Quail Brush Genco, LLC

Cogentrix Quail Brush Generation Project - Docket Number 11-AFC-3, Supplement 2 to the AFC

Data Request Responses to Set 1 for
the Quail Brush Generation Project
(11-AFC-3)

March 2012

Figure 4. Permitted Landfill Locations in San Diego County

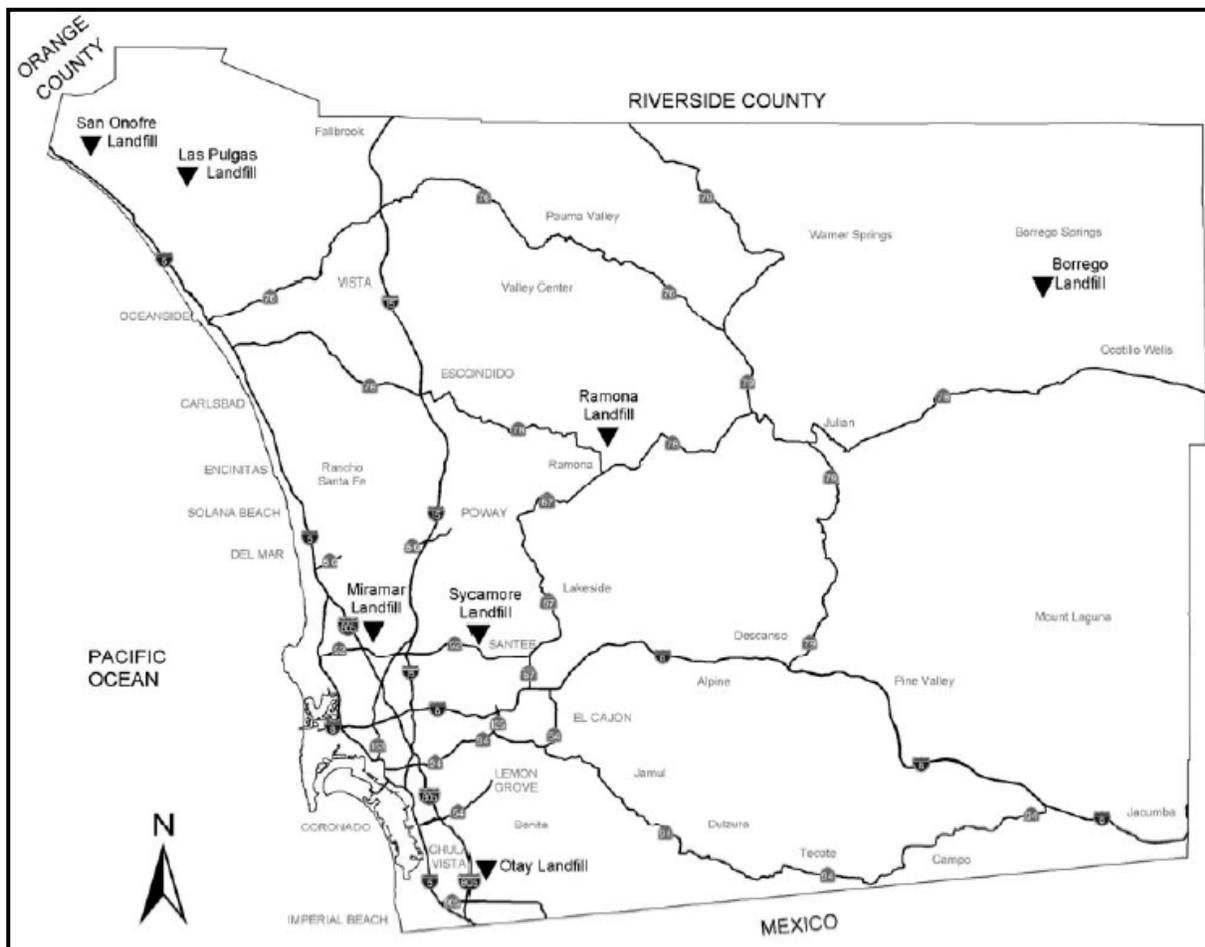
33. Please provide historic contexts as they relate to the Old Mission Dam, Camp Elliot, and Sycamore Landfill and, respectively, to the local development of water control infrastructure in the Spanish Colonial era, the military use of the project area vicinity, and the local development of waste disposal systems.

The Sycamore Landfill accepts City waste and handles approximately one-third of the current waste generated in the City of San Diego. The landfill was initially permitted in 1963 when the City issued Conditional Use Permit (CUP) #6066 to the County of San Diego, who owned the site at that time. The CUP authorized the County to construct and operate a sanitary landfill on 113 acres within Little Sycamore Canyon. The CUP was amended in 1974 to increase the size to 493 acres and approved a plan to eventually fill the entire canyon with solid waste. The County continued to operate the landfill until 1982. At that time, a private contractor was hired to operate the landfill. In 1997, Allied Waste Industries purchased the property and landfill business as part of a purchase of all County-owned solid waste assets. Today, the landfill is owned and operated by Sycamore Landfill Inc., a subsidiary of Allied Waste Industries pursuant to a Franchise Agreement with the City. This agreement states that Sycamore Landfill will provide capacity for City residential waste following closure of the City's Miramar Landfill, currently scheduled for 2012 (2017, pending approval of applications). Attachment D provides a list of granted permits and other government actions associated with Sycamore Landfill to document the landfill's history of development (BRG 2008:1-1, 2-1). As of 2008, approximately 150 acres (Figure 1B) have been disturbed by prior and on-going landfill operations (BRG 2008:2-1).

**FIGURE 2A
POTENTIAL MITIGATION SITES**

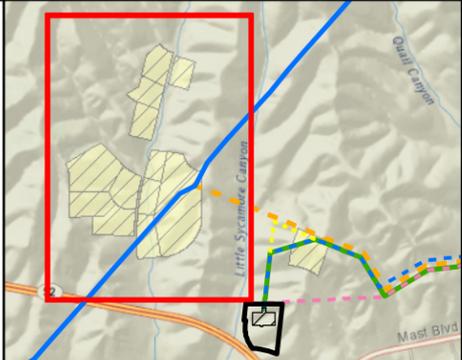
28. Please provide on a map at a scale of 1:6,000 or color aerial photographs taken at a recommended scale of 1 inch equals 500 feet (1:6,000) with a 30 percent overlap of location(s) of potential mitigation sites.

FIGURE 3
QUAIL BRUSH SURVEY AREAS

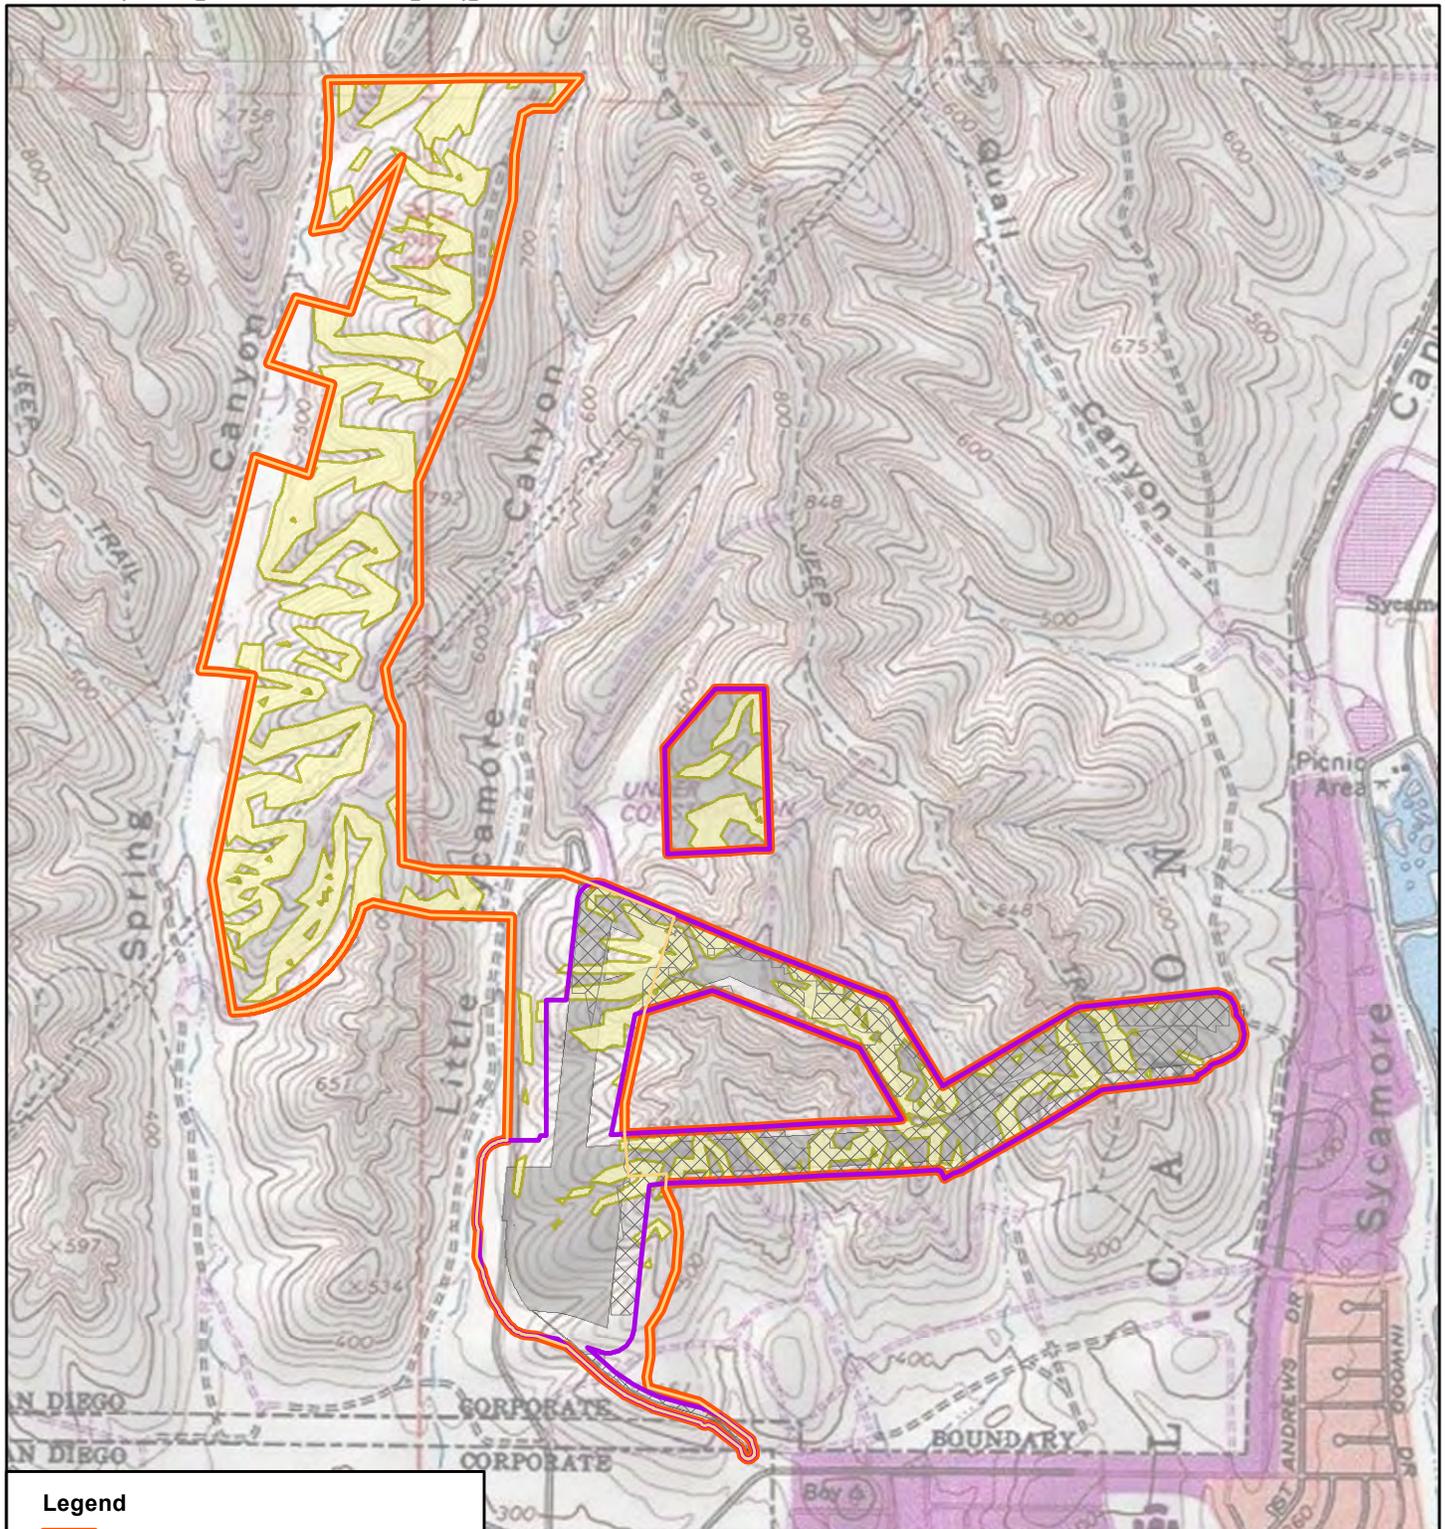
32. Please provide the draft report of the supplemental archaeological fieldwork as identified in the Applicant’s November 7, 2012 submission. If additional time is needed to complete the fieldwork or report, please provide a schedule for completion of the fieldwork and date of report submission.

A portion of the supplemental archaeological fieldwork was completed January 3-10, 2012, however not all private parcels were accessible at that time (see Figure 3 for a map showing areas surveyed). This work was conducted within the survey area for the Project area described in Supplement 2 to the AFC, submitted to CEC on February 8, 2012. A confidential draft report documenting the results of the January 2012 fieldwork, entitled *Preliminary Results of a Supplemental Cultural Resources Survey for Quail Brush Genco, LLC's Quail Brush Generation Project, San Diego, California*, was docketed at the CEC under a confidentiality request on February 16, 2012.

Access to additional private parcels within the revised layout has been achieved (although not all parcels will be included). Therefore, additional supplemental survey work must be conducted and is currently planned for March 5-13, 2012. Figure 3 depicts areas requiring survey using the vegetation removal unit methodology described in the revised survey design docketed on November 7, 2011. Further, the additional fieldwork will include recordation and evaluation of the Sycamore Landfill, as requested in Data Request #34, below. A second supplemental report documenting the additional field efforts will be provided to the CEC under confidential cover no later than April 27, 2012.

ATTACHMENT G
CARLTON HILLS 138 KV SUBSTATION PLAN

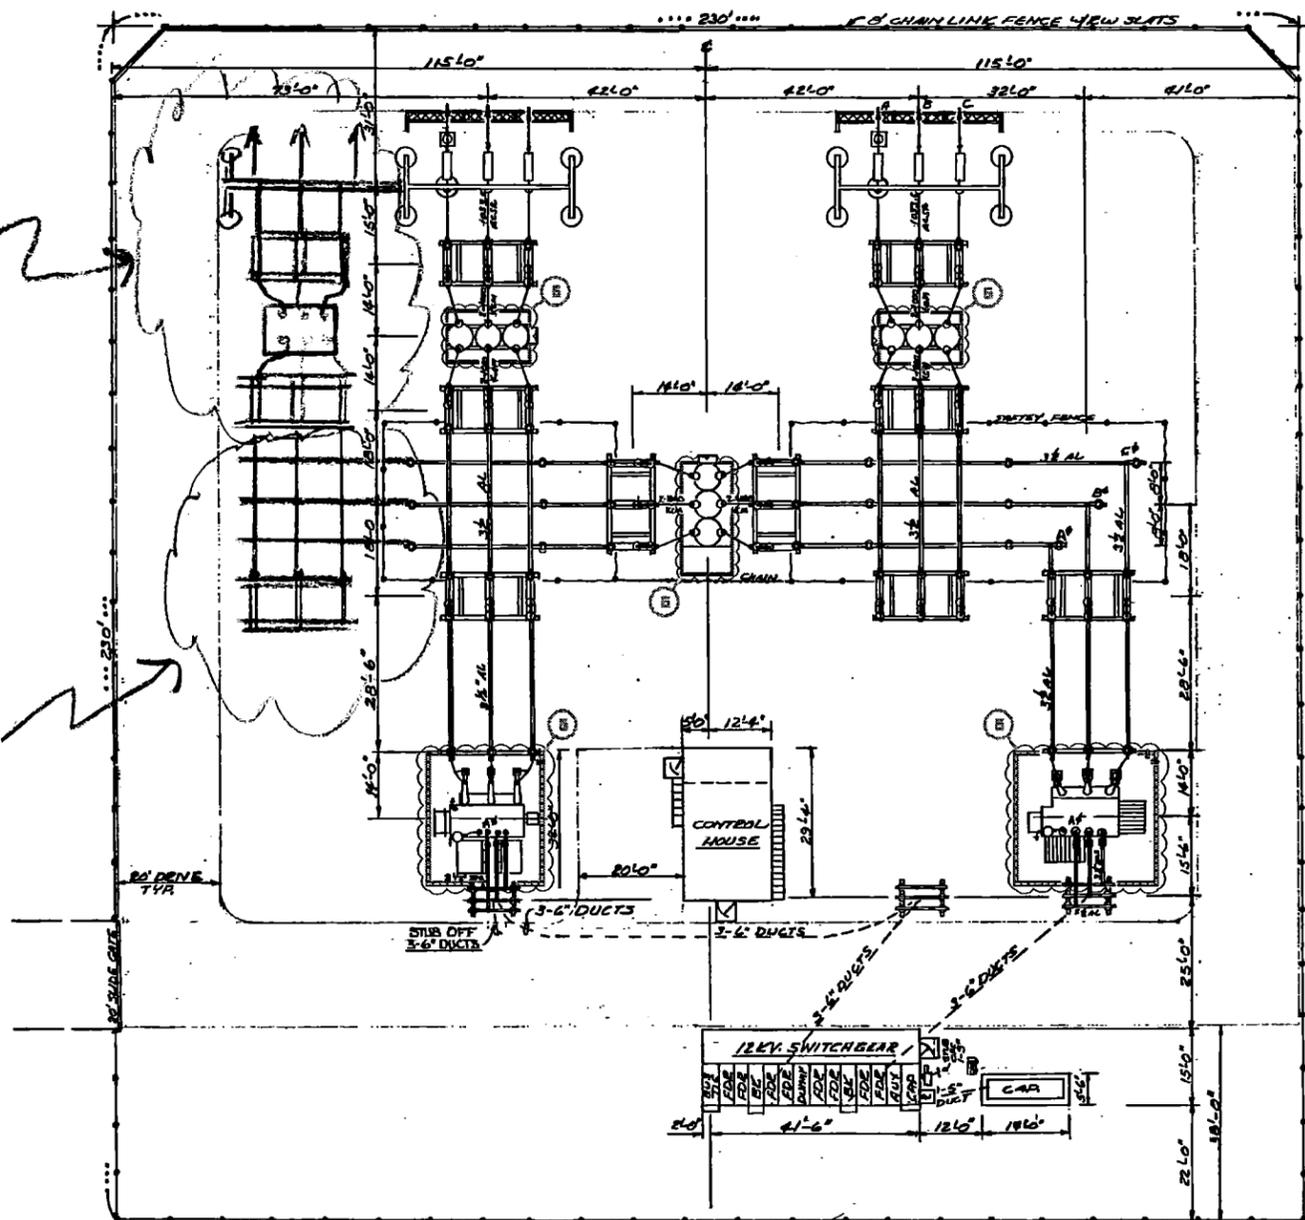
55. Provide a physical layout drawing of the QBGP 230/13.8 kV switchyard showing all major equipment (generators, buses, transformers, breakers and disconnect switches etc.) and transmission line outlet(s).

The Applicant docketed Supplement 2 to the AFC on February 8, 2012, which addresses the new gen tie proposed route and facilities. Since the Project Point of Interconnection is no longer 230kV, the QBGP 230kV/13.8 switchyard associated with the Project will become the 138 kV switchyard. The GSUT (138/13.8 kV) is outside the switchyard boundary. The QBGP switchyard will be located on the QBGP site immediately north of the power block. The physical layout drawing of the QBGP 138 kV switchyard is included as Attachment F. The new Point of Interconnection is the 138 kV bus at the existing SDG&E Carlton Hills Substation. Attachment G is a plan of the Carlton Hills Substation. SDG&E will proceed with design of the Carlton Hills Substation modifications once the final gen tie route has been selected.
